**MR-1512F**

Application	General Data	
<b>Project Name:</b> Andrews Federal Campus - Southern Avenue Bus Garage Replacement Project  <b>Location:</b> Southern Ave/Boones Road  <b>Applicant/Address:</b> Southwest intersection of Suitland Parkway and the Capital Beltway  <b>Property Owner:</b> Washington Metropolitan Area Transit Authority (WMATA)	<b>Planning Board Hearing Date:</b>	07/30/15
	<b>Staff Report Date:</b>	July 30, 2015
	<b>Date Accepted:</b>	June 03, 2015
	<b>Mandatory Action Timeframe:</b>	60-Day Review
	<b>Acreage:</b>	35 acres
	<b>Zone:</b>	I-4
	<b>Planning Area:</b>	76A
	<b>General Plan Tier:</b>	Established Communities
	<b>Council District:</b>	District 8
	<b>Adjacent Municipality:</b>	Town of Morningside

# **MR-1512F Staff Report – Proposed Replacement of the Existing Southern Avenue Bus Garage**

**SUBJECT:** Mandatory Referral MR-1512F (formerly MR-1320)  
Andrews Federal Center Bus Garage (formerly known as the Southern Avenue  
Bus Garage Replacement)

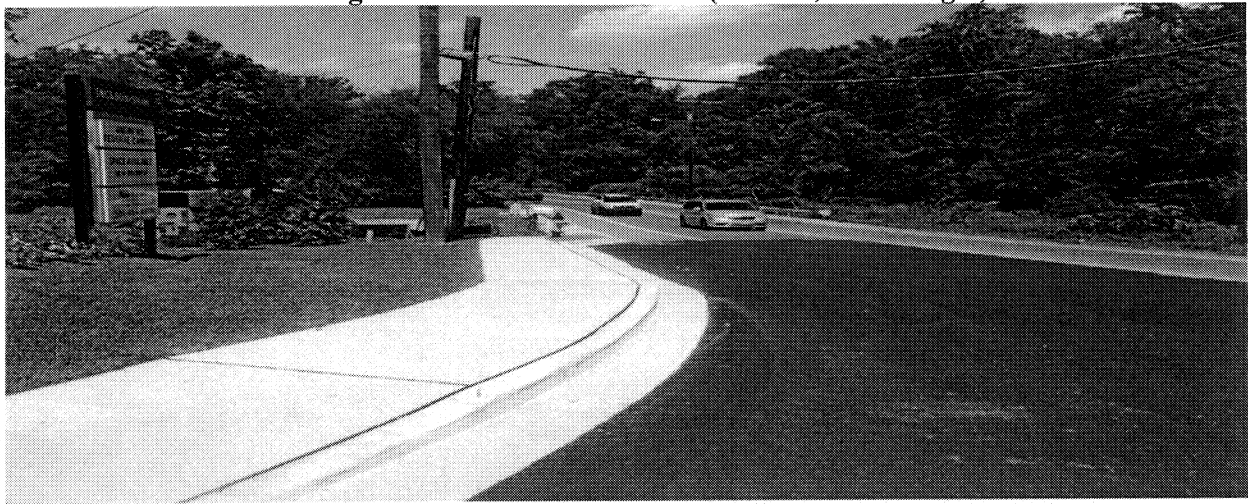
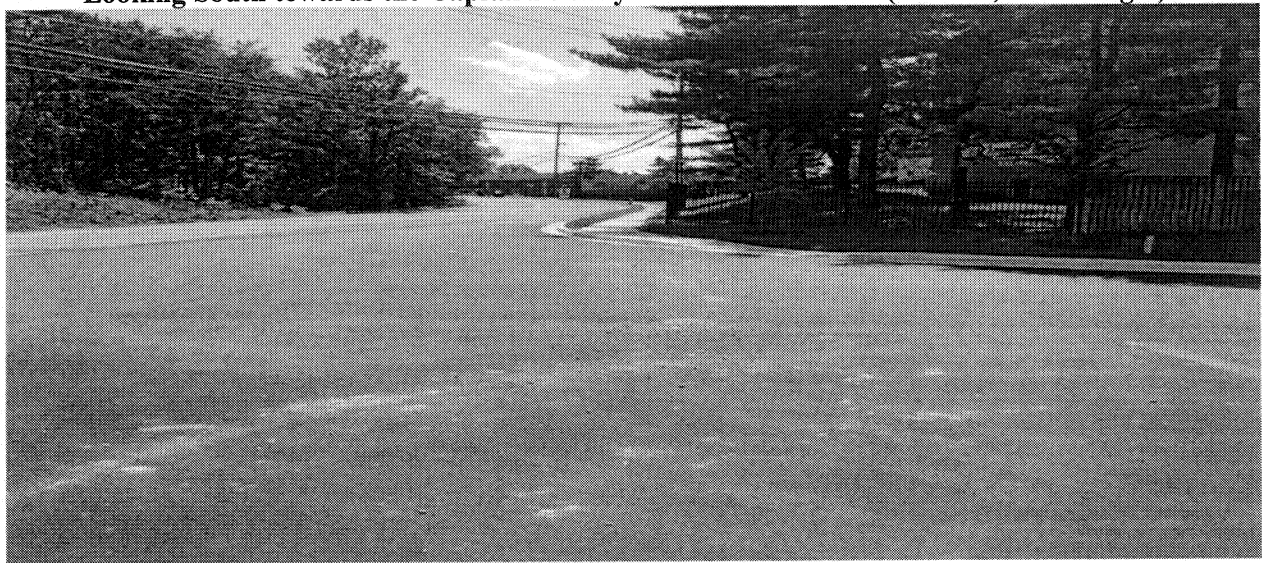
The area is served by Metrobus K-12 along Forestville Road. The nearest transit station is the Branch Avenue Metrorail Station. Forestville Road can be accessed by new concrete sidewalks on the entrance road to the campus. Sidewalks have also been improved along Forestville Road, with the Americans with Disabilities Act (ADA) ramps (See attached images).
